ADDENDUM 002

BID# 01MOT27 Will Rogers Elementary School HVAC Replacement Project
Building H– DSA Application #03-125978
September 28, 2026

SHEET NO:
M-0.2 ADD02

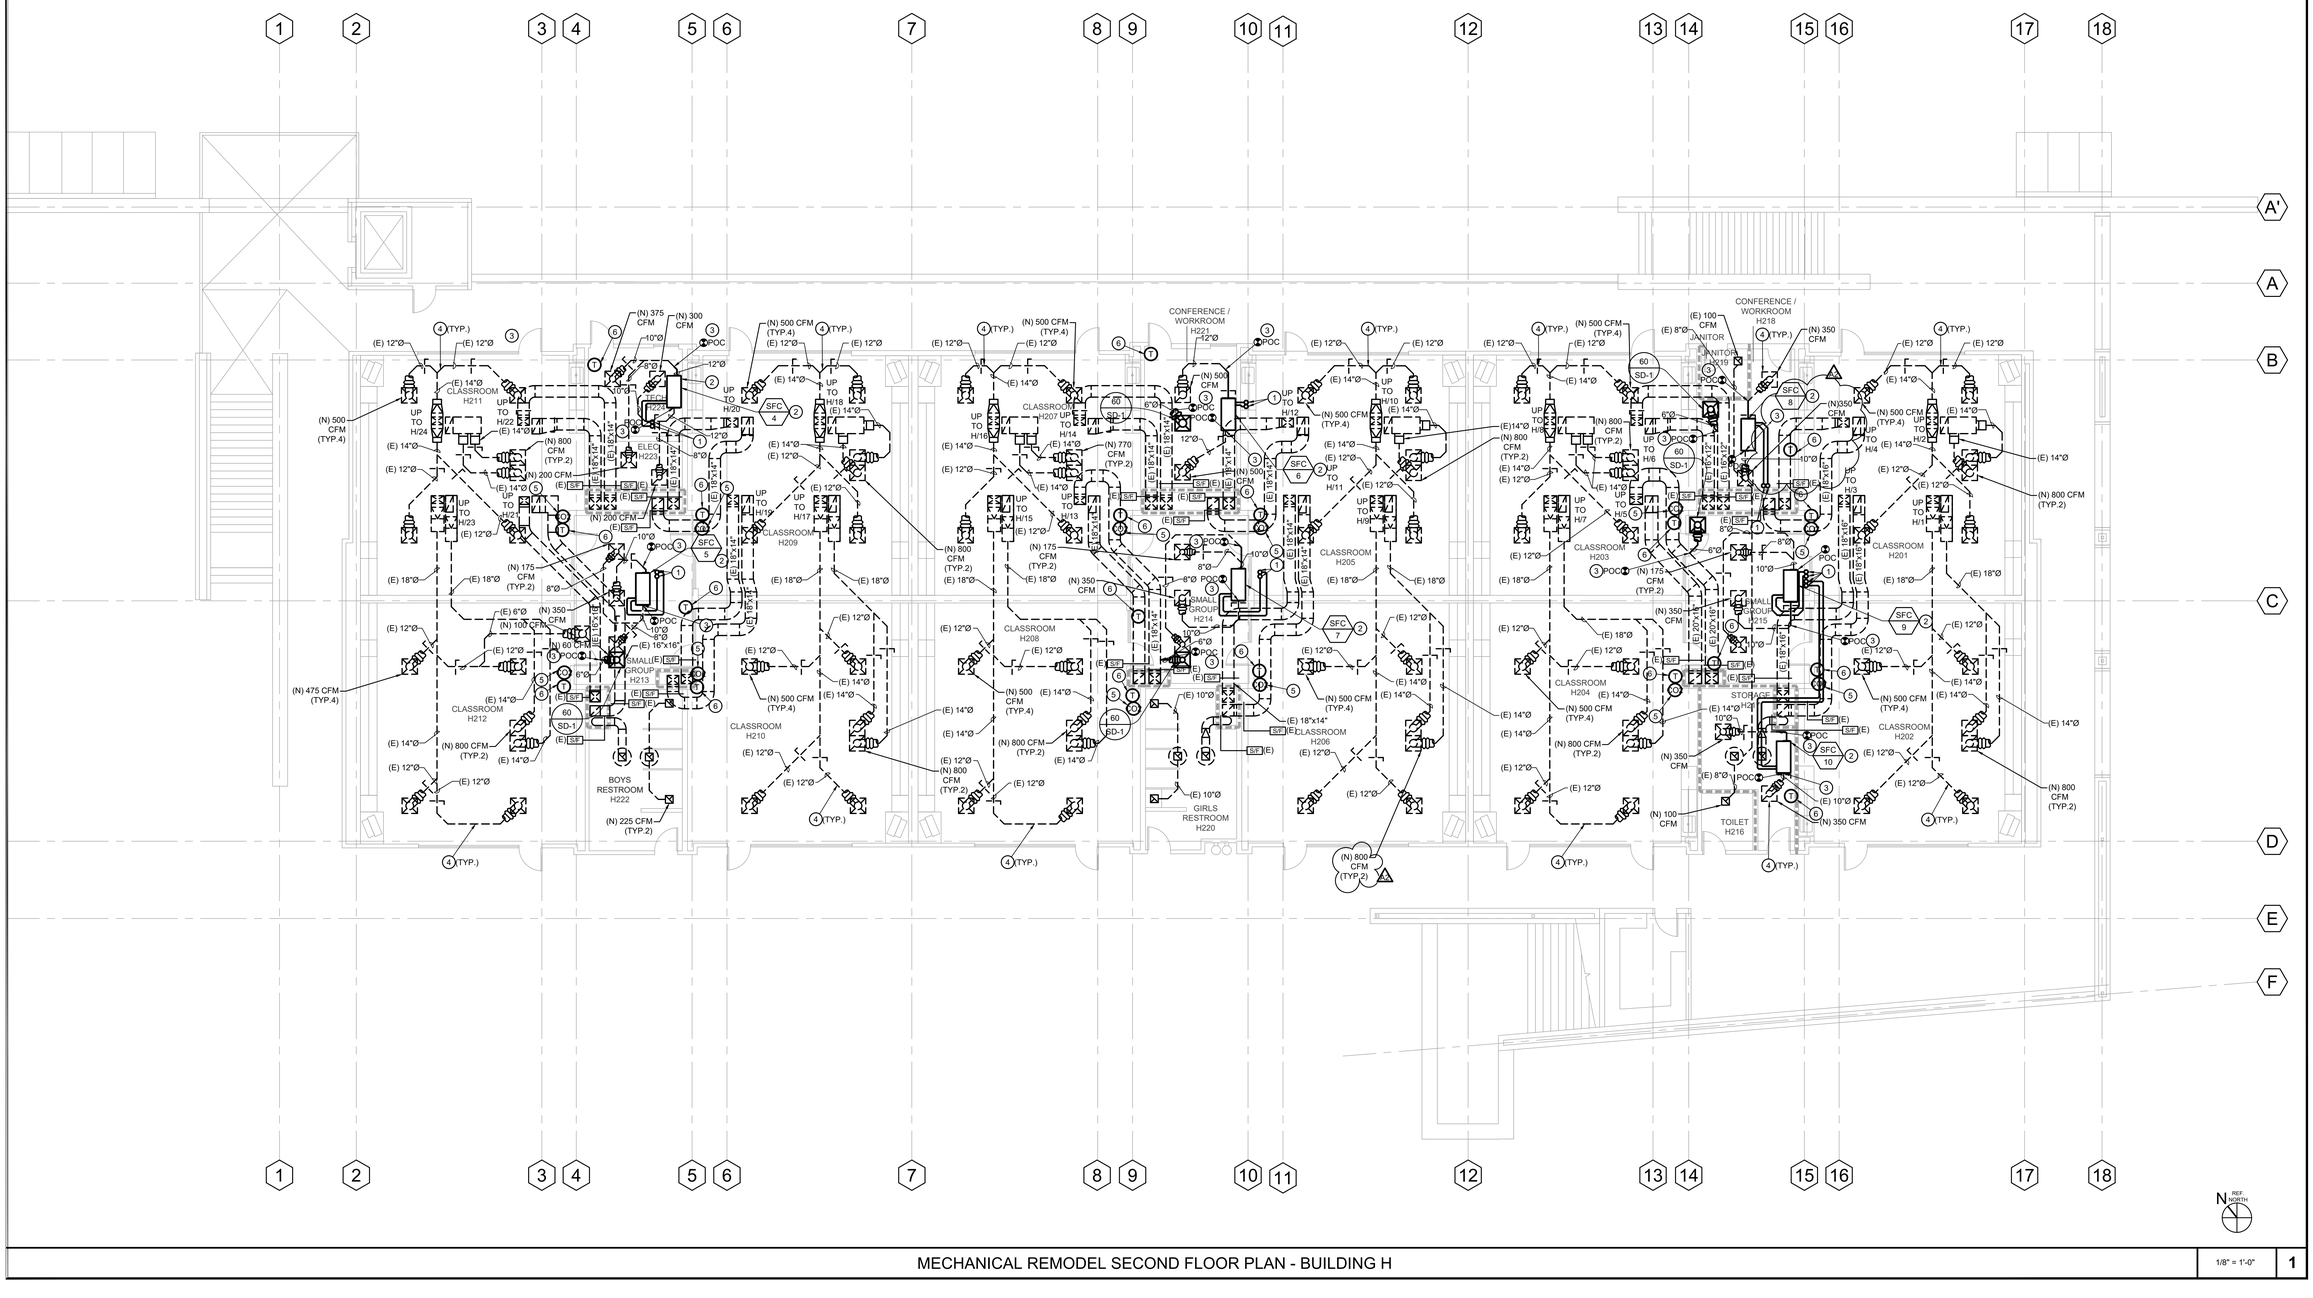
4.1-1.1.1. Revision to remark 2 on Split System Outdoor Unit Heat Pump Schedule.

SHEET NO:
M-1.2 ADD02

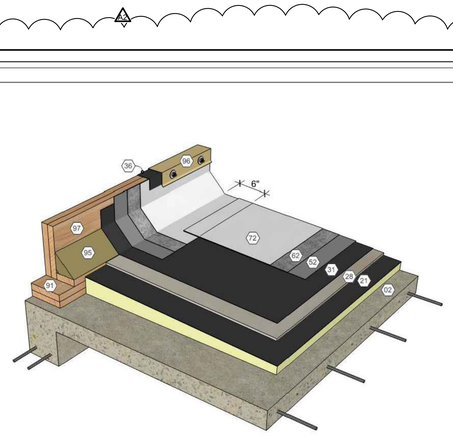
4.1-1.3.1. Revised CFM from '(E)' existing to '(N)' for new airflow on air devices in classroom H206, per attachment.

4.1-1.3.2. Revised CFM from '(E)' existing to '(N)' for new airflow on air devices in workroom H218, per attachment.

4.1-1.3.3. Removed redundant diffuser in workroom H218 that does not exist and indicates balance to 350 CFM.

SHEET NO:
M-4.2ADD02

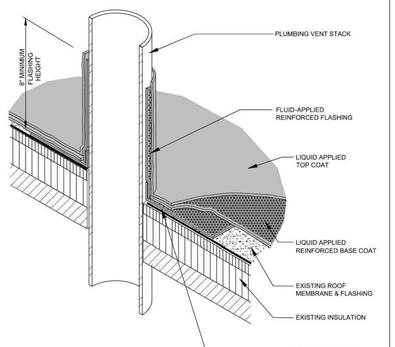
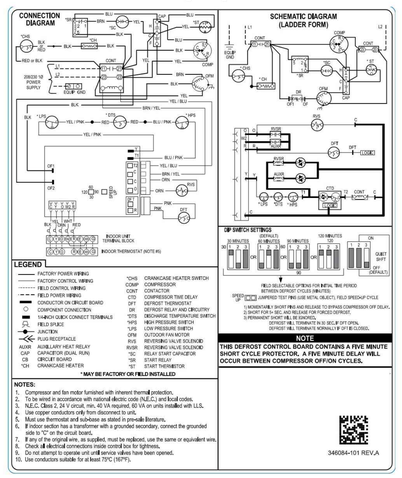
4.1-3.1.1. Added detail 3/M-4.2 for roofing product data, per attachment.

4.1-3.1.2. Removed redundant diffuser in workroom H218 that does not exist and indicates balance to 350 CFM.
